Mr Robert Powell
Project Manager
NWCC
National Grid

6th January 2017

Friends of the Lake District Response to National Grid's North West Coast Connections (NWCC) Preliminary Environmental Impact Report.

The LDNPA LCT mapping (top) and National Grid's cropping of the LCTs at the National Park boundary

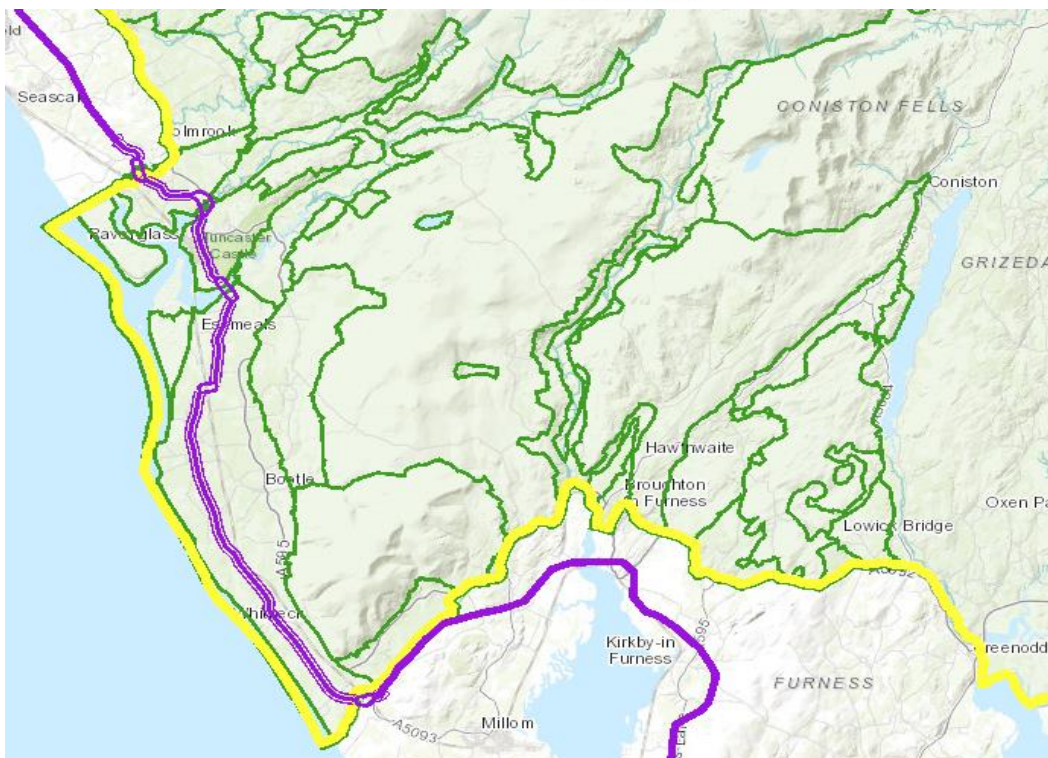
41. There are a number of places where Lake District National Park Landscape Character Types (LCT) cross the boundary of the National Park e.g. Type B, Type F and Type J. As shown on the maps below, these boundary-crossing LCTs have been systematically cropped at the boundary

on all the maps in National Grid's consultation which show LCTs. No explanation has been given for this omission of information. By National Grid.

42. In the text of the PEIR there is no mention that some of the LDNPA LCT's cross the National Park boundary. The PEIR uses alone and without explanation the Cumbria County Council LCT descriptions. This is despite the fact that these areas lie within a Lake District Landscape Character Type and have the same characteristics as the landscape within the National Park. Landscape character does not stop at man-made boundaries.
